# OneSteel

## Responses to OneSteel submission

We thank OneSteel for its comments on the Terminal and Transport PHAs and for provision of the results of its own investigators so that we could more fully respond to OneSteel's concerns. We would be pleased to discuss our response if further clarification is required.

*Figure 1 Single Tank-top fire, ND16 – heat radiation of 4.7 kW/m<sup>2</sup> at 1.5m height*

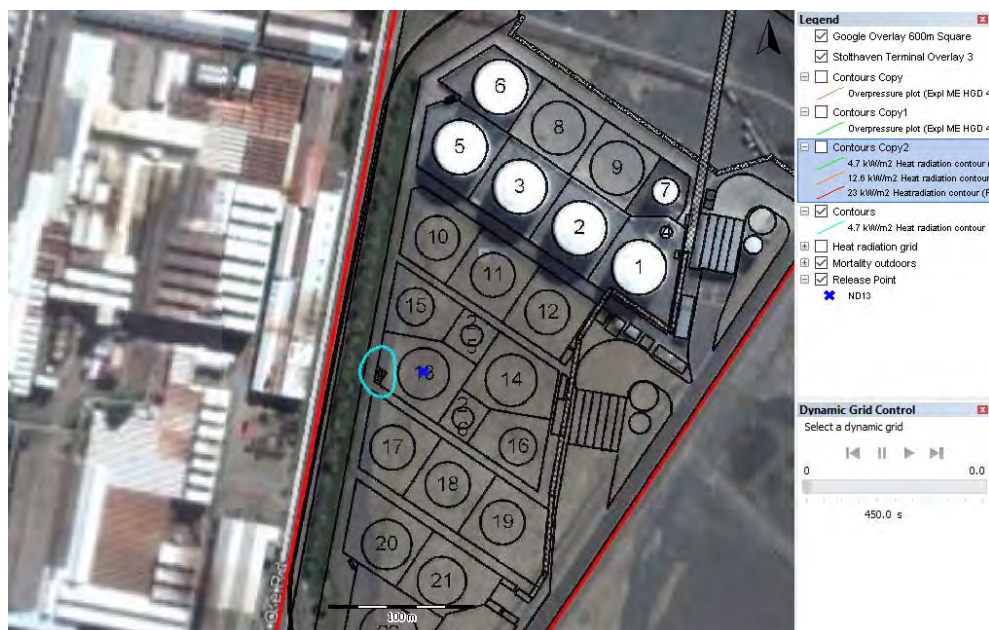
For a tank fire, the primary impact is heat radiation. Figure 1 shows the 4.7 kW/m<sup>2</sup> heat radiation plot at 1.5m height for a single tank fire for a wind speed of 10 m/s (easterly). Figure 2 is a compilation of heat radiation contours for all tanks close to the railway line on the western boundary of the site, with a wind speed of 10 m/s and various (generally easterly) wind directions, also presented as 4.7 kW/m<sup>2</sup> contours.

*Figure 5 Incident Overpressure Contours – F2.0 Easterly*

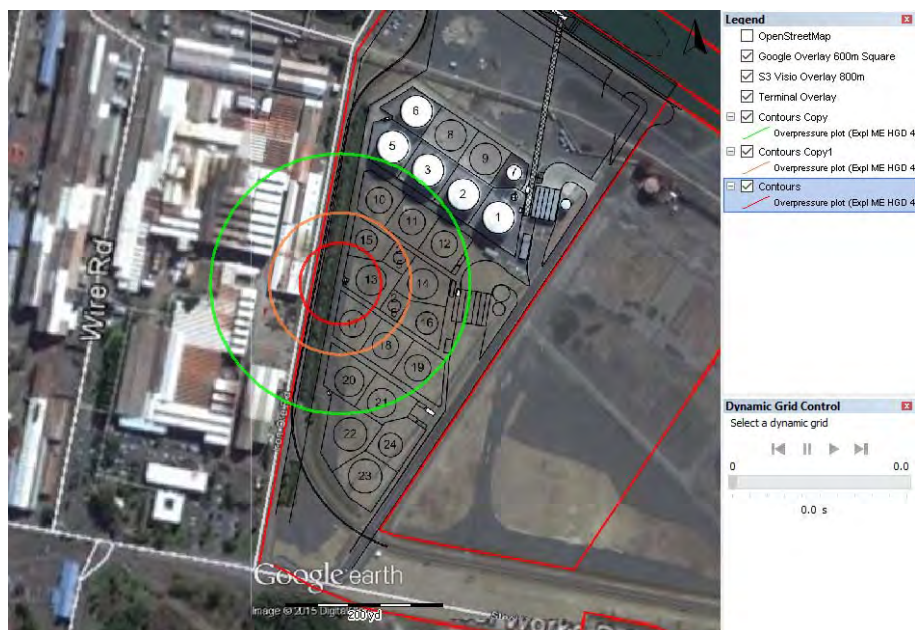
Figure 5 shows the overpressure contours (at 7 kPa, 15 kPa and 35 kPa) resulting in ignition of a vapour cloud for F2.0 conditions (easterly wind).

**Figure 7 FN Curve for Stolthaven Newcastle Terminal Stage 3**

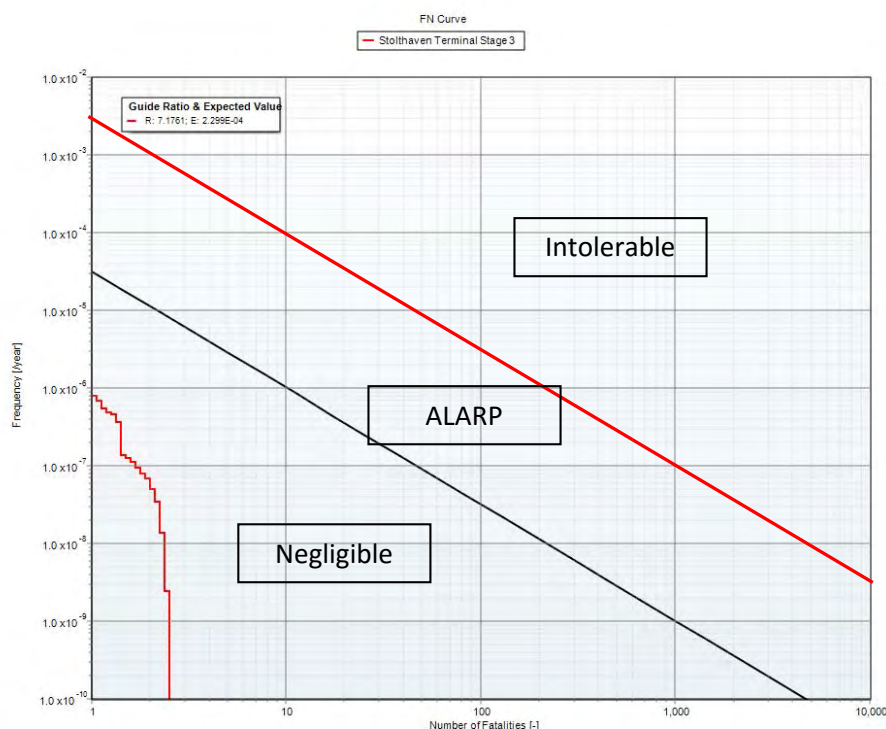
Inspection of Figure 7 shows that the calculated FN curve is well below the indicative negligible level of HIPPA 4. This is what would be expected for a fuels terminal located in an industrial area and separated from high density residential land use. This was anticipated by DP&E based on its experience with other fuels terminals and was the reason why it did not require the PHA to examine societal risk.

Figure 9 Individual Injury Contours (Toxic Inhalation, Mild Transient Effects)

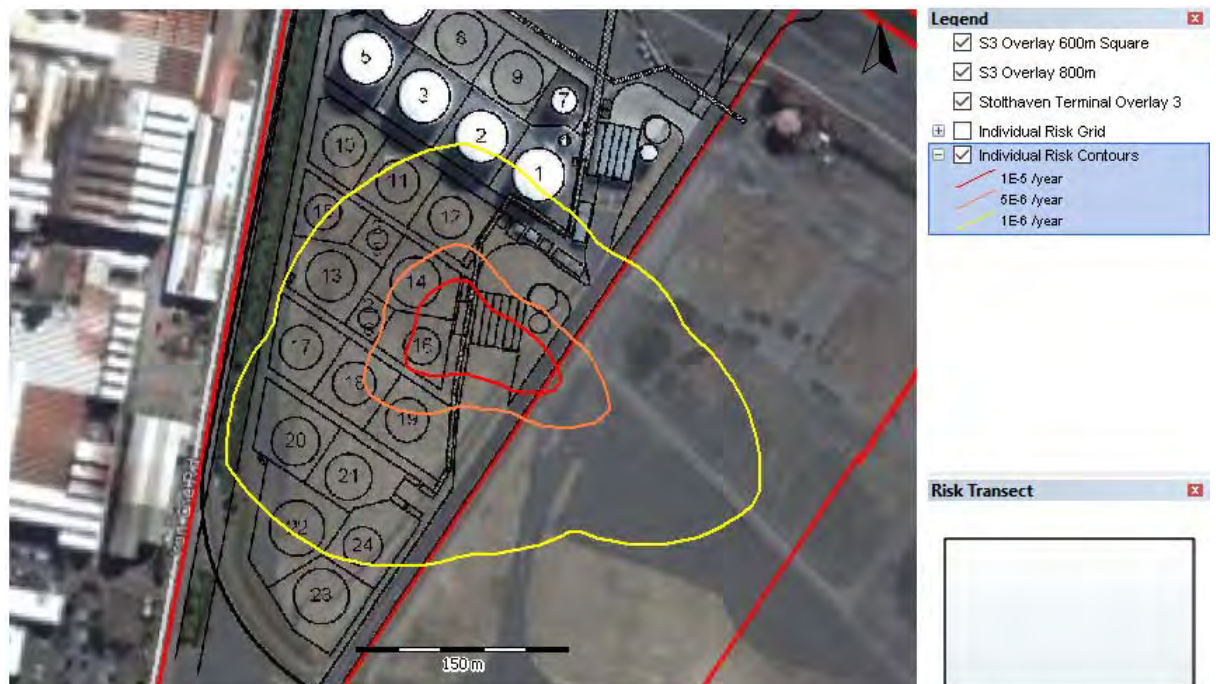
The individual contribution to the Individual Fatality contour is shown as iso-probability contours in Figure 8, below. Iso-probabilities for mild, transient effects are presented in Figure 9.

Inspection of Figure 8 shows that the Individual Fatality Risk at a level of  $1 \times 10^{-7}$  pa is contained within the terminal site boundaries. Inspection of Figure 9 shows that the exposure equivalent to 30 minutes at the TWA level for personnel on the OneSteel site will be less than one in a million per year.

**Figure 11 23 kW/m<sup>2</sup> (blue), flash fire and 14 kPa Contours (southerly wind)**

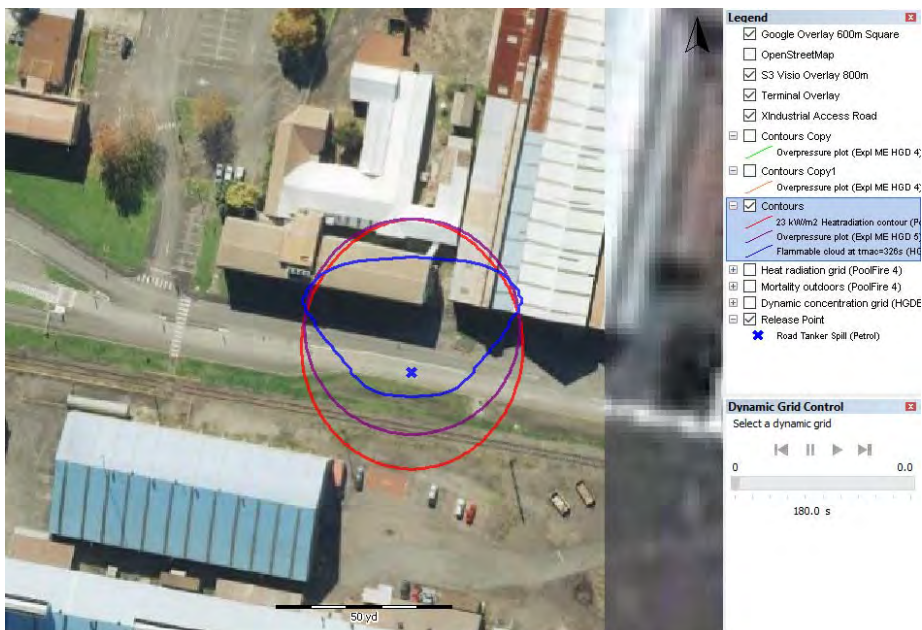
Figure 11 below shows the consequence contours for a 1,500kg spill of petrol on Steelworks road for a loaded petrol tanker leaving the Stolthaven site (flammable vapour cloud at maximum extent – blue; incident heat radiation at  $23 \text{ kW/m}^2$  – red, and incident overpressure of 14 kPa – purple). The range of spill sizes and spill frequencies considered in the QRA is provided in Table 11 of the PHA. The frequency of accidents involving a spill and
